# DEFENSE DISTRIBUTION DEPOT MEMPHIS

NO FURTHER ACTION  
REPORT

EPA COMMENTS  
NO FURTHER ACTION REPORT  
FIRST DRAFT, SEPTEMBER 1994  
DEFENSE DISTRIBUTION DEPOT  
MEMPHIS, TENNESSEE

**Tennessee Department of Environment and Conservation**  
**Division of Superfund**  
**Comments for**  
**NO FURTHER ACTION REPORT**  
**DEFENSE DEPOT**  
**Site Number 79-736**  
**8/11/95**

Figure 1.2  
Site Locations Map  
Defense Depot, Memphis, Tennessee

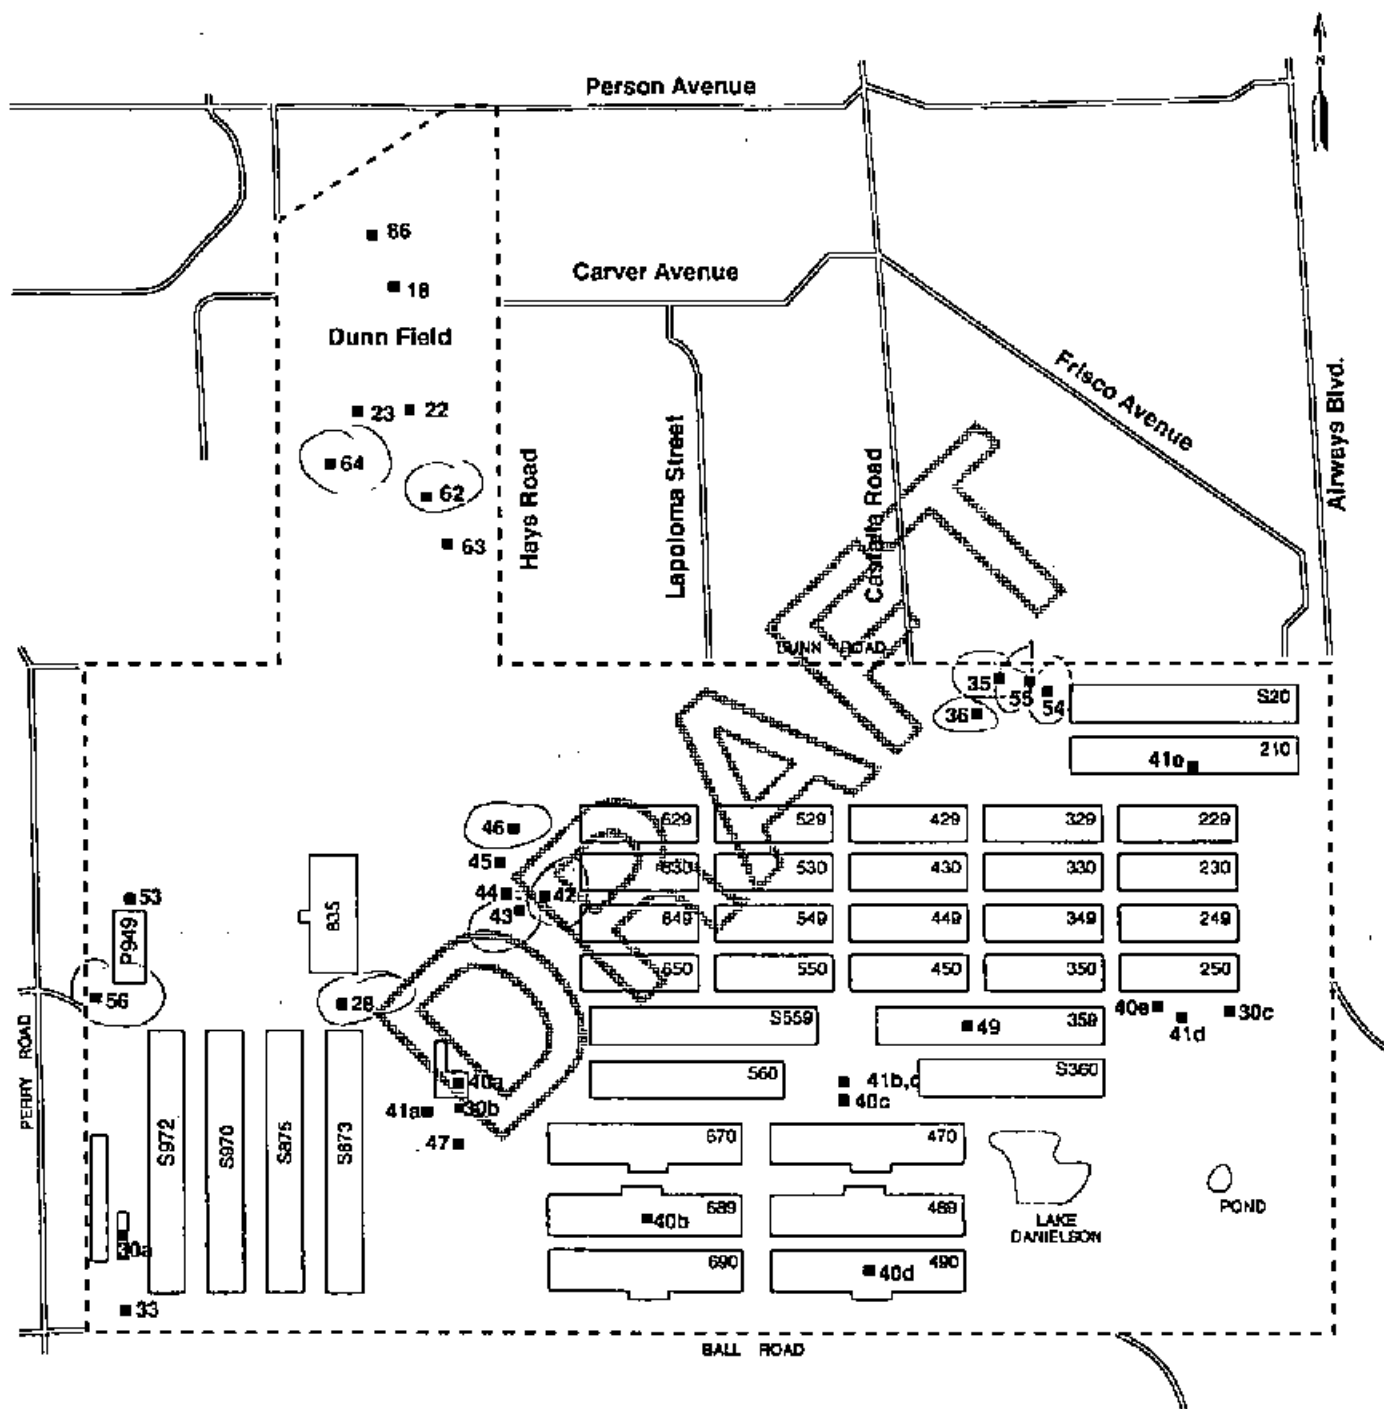
1. Figure 1, 2, page 1-3 --Numerous "No Further Action" sites are shown on this map that do not correspond to those listed in table ES-1. Please correct or clarify.

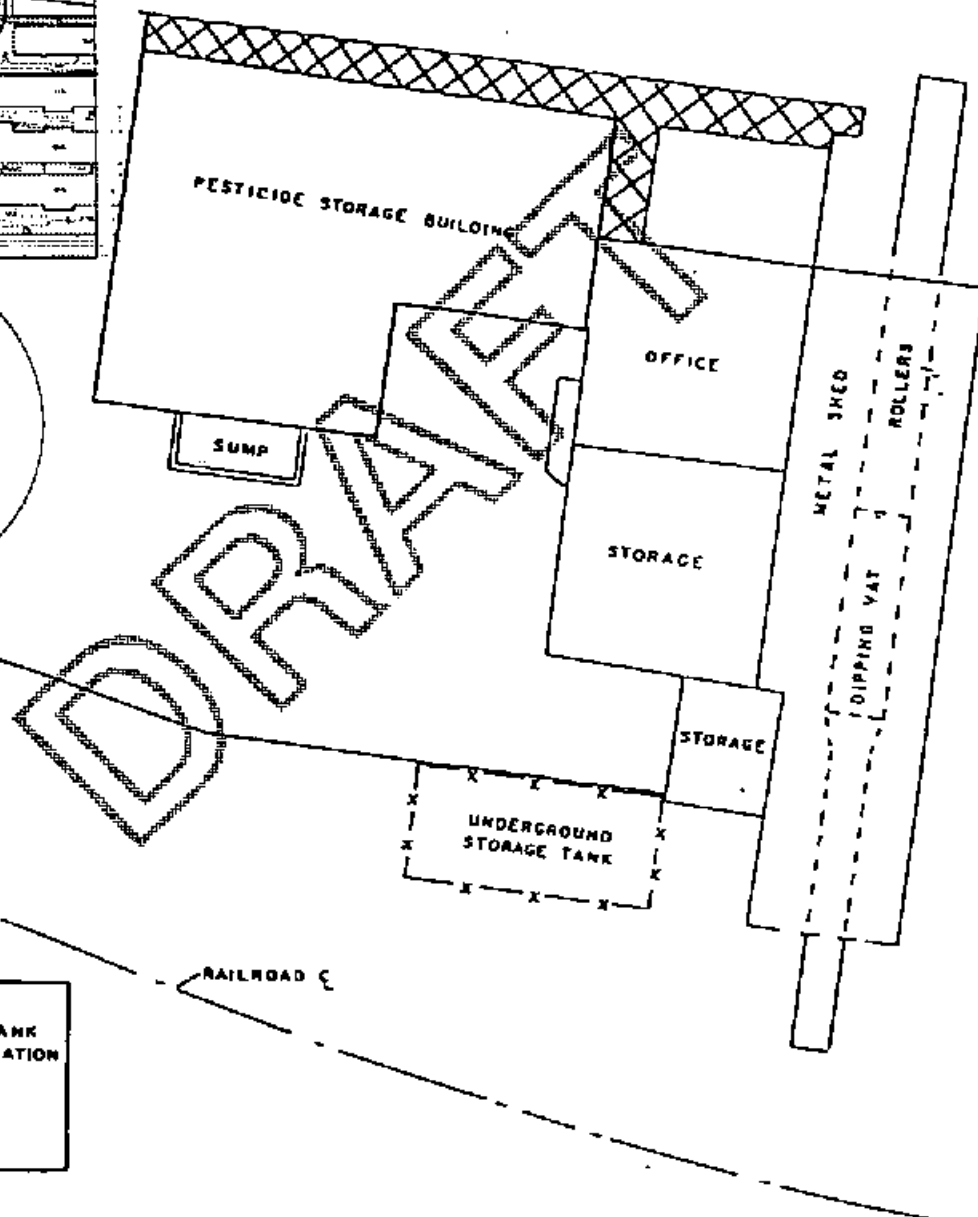
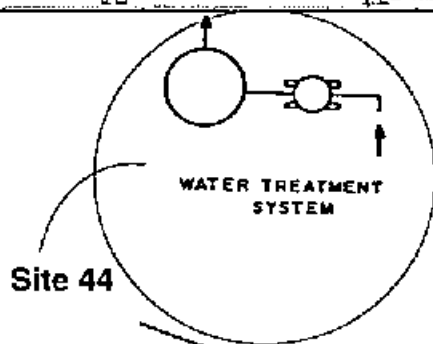
9. Figure 2.7, page 2-15--This map is confusing. The legend does not appear to relate to the drawings. The relationship of the enlarged areas to the insets is unclear. TDEC suggests providing a better figure to illustrate this site.

Figure 2.8  
 Site 45

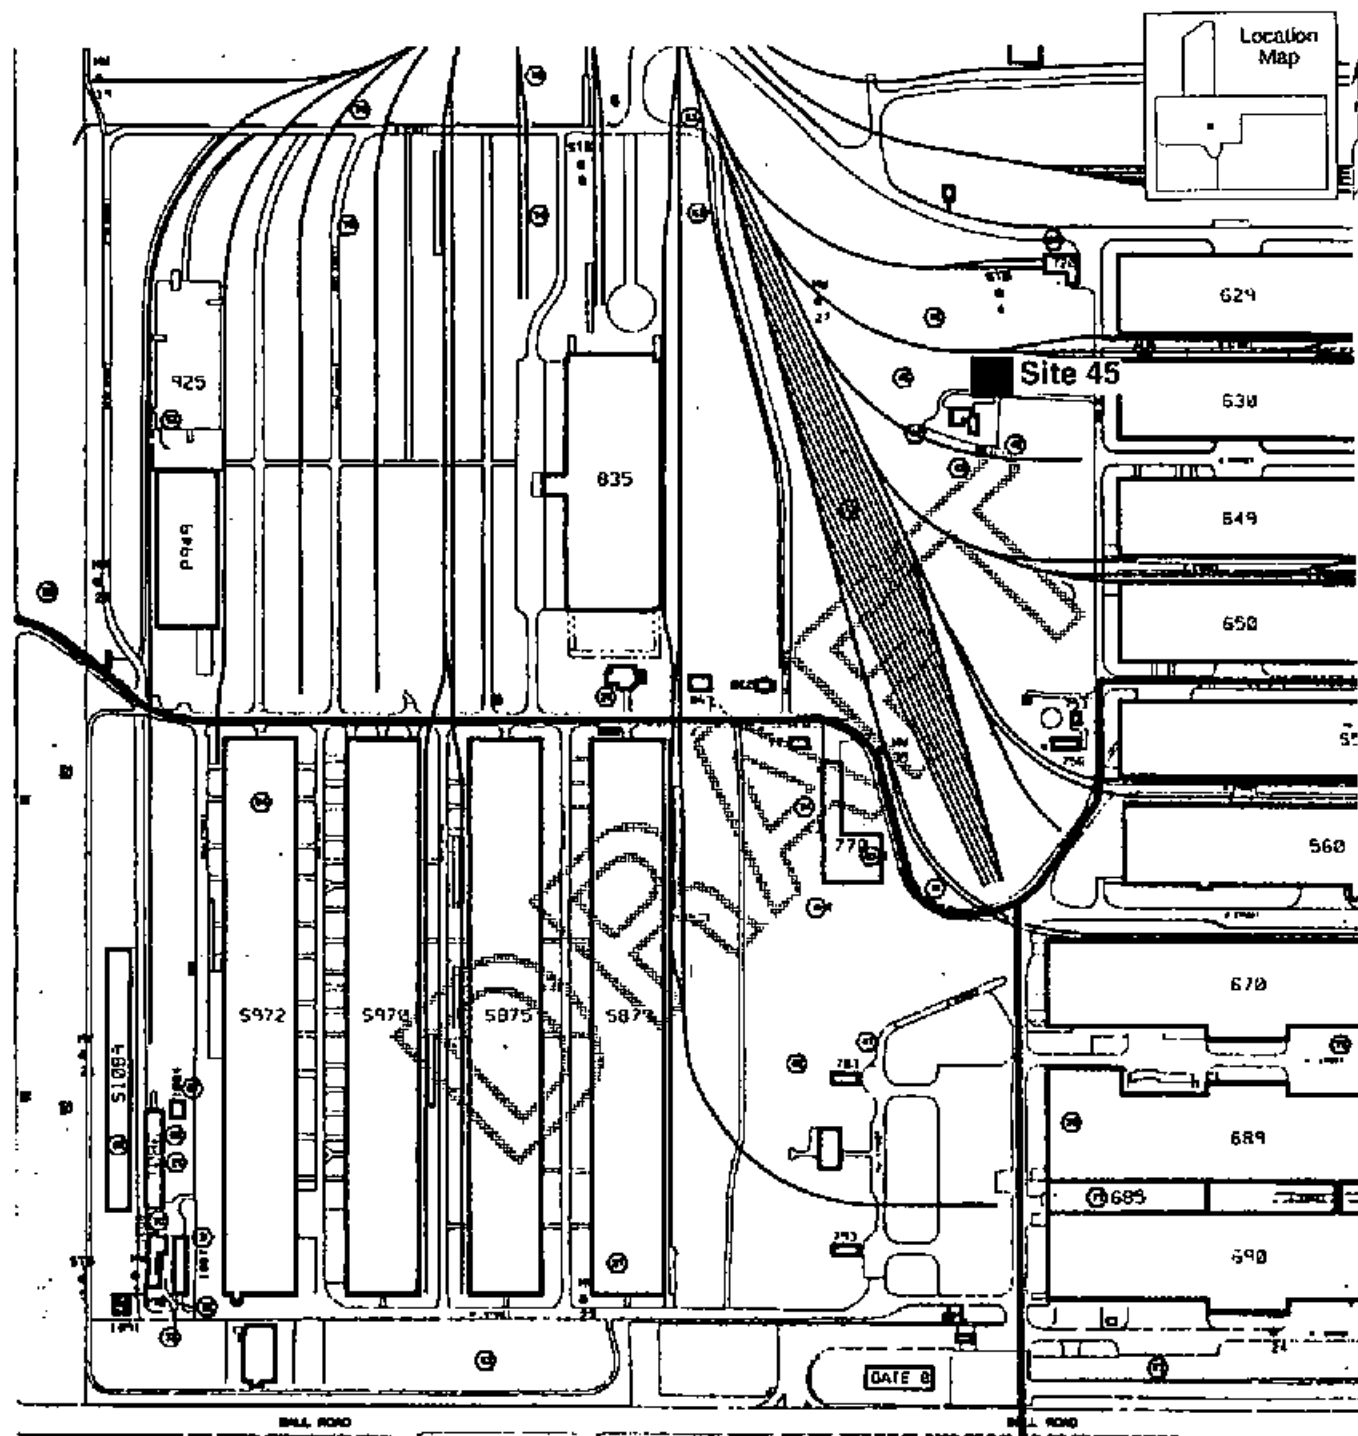
Site 45 is a former temporary storage area that was used to store material from the PCP tank and vat area remediation while it awaited offsite disposal. According to the information provided, up to 39 roll-off containers were placed in the area and were filled with material and covered with plastic while awaiting transport. EPA is concerned that there may have been spillage of contaminated material when the roll-offs were being loaded. More information is needed before this site can be assigned to the NFA category.

10. Section 2.8.2, page 2-16, last sentence--What units appeared to be in good condition? It is very likely that this site will require some confirmatory sampling before it can be accepted as NFA.

Figure 2.11  
Site 53

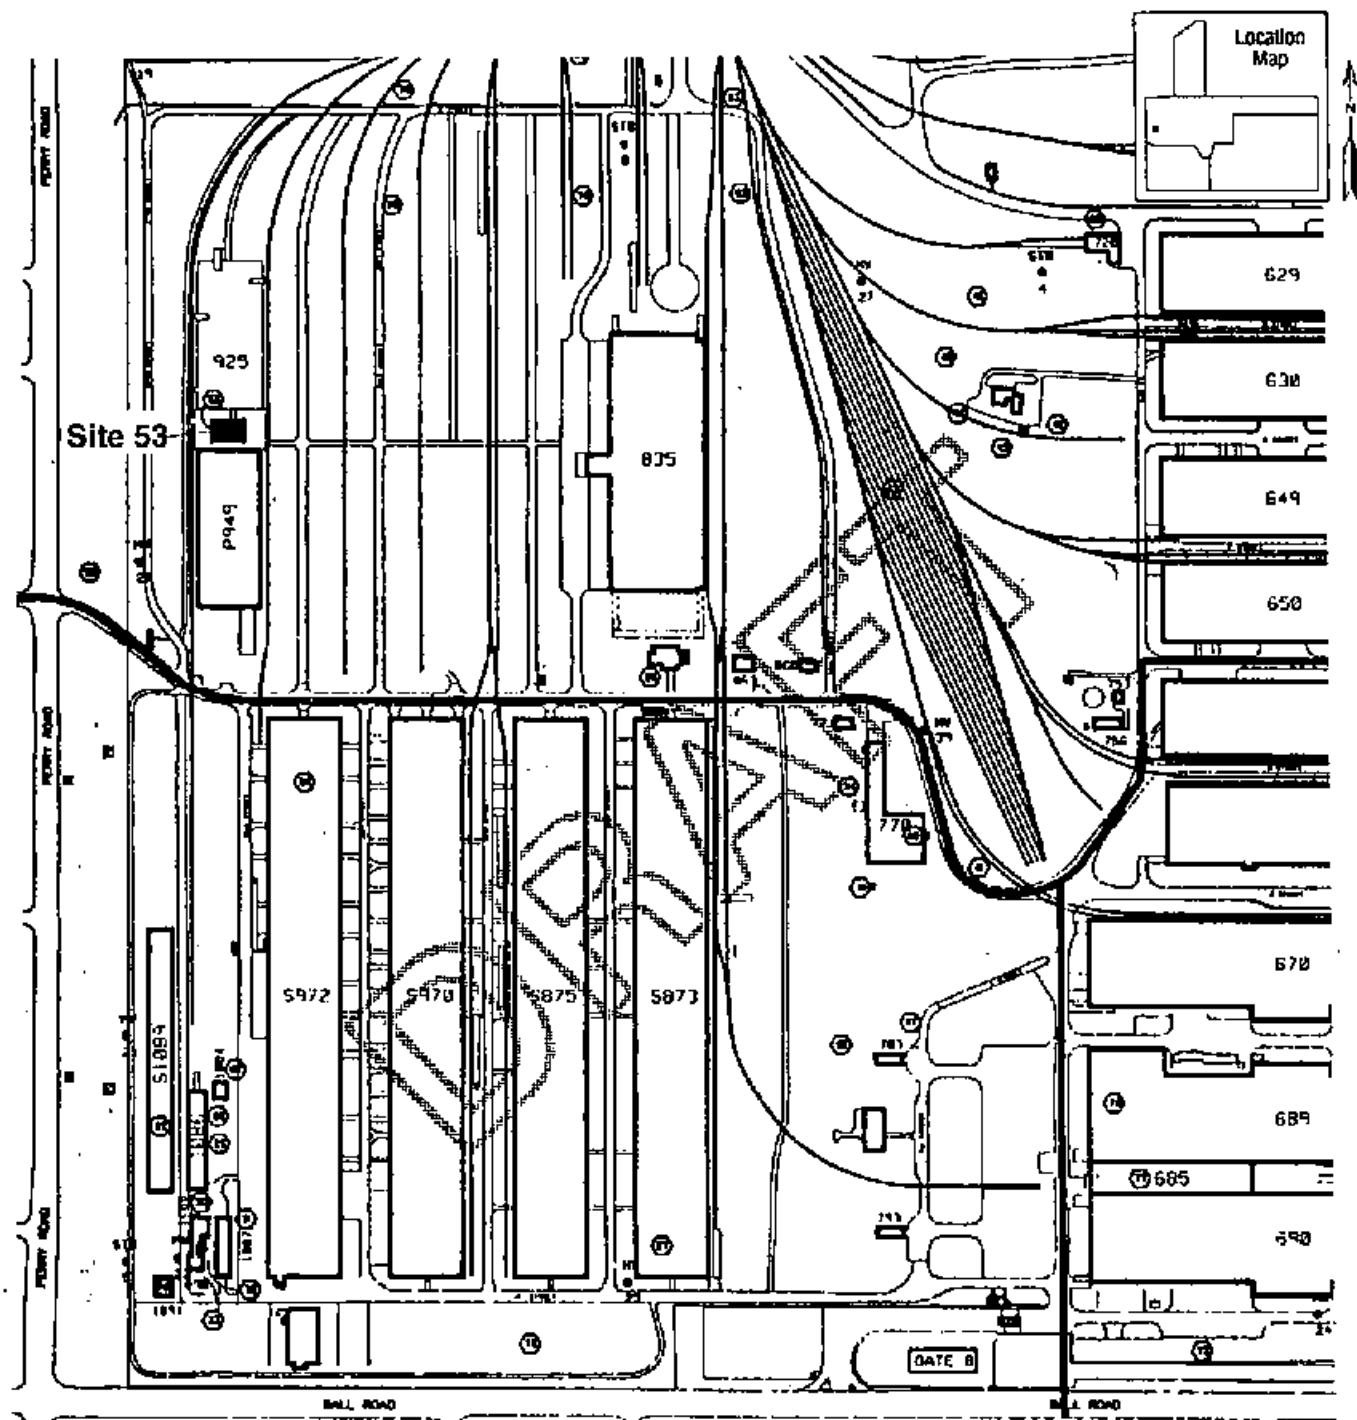
Site 53 is the Flammable Solvents Storage Area. A 36,000 gallon spill occurred on January 19, 1988 and, according to a 1/25/88 City of Memphis memo on the subject (Appendix C in the NFA Report), 11,000 gallons were recouped and 1500 to 2000 gallons were lost. EPA disagrees with NFA recommendation for this site. This site should be classified as a Site Screening/Early Removal site.

14. Section 2.1.1, page 2-22--The verbiage within this section is directly contradictory to that included in the appendix as it relates to indication of release. A 1,500-2,000 gal. loss is hardly rationalized as "...no indication of a release to the environment.". I question the judgement in drafting this narrative in a manner that can only be construed as misleading. This site is definitely not an NFA site. Furthermore, it will probably require a site specific characterization of the vadose zone and shallow aquifer. Further characterization may also be required if results indicate any potential for deep aquifer contamination.
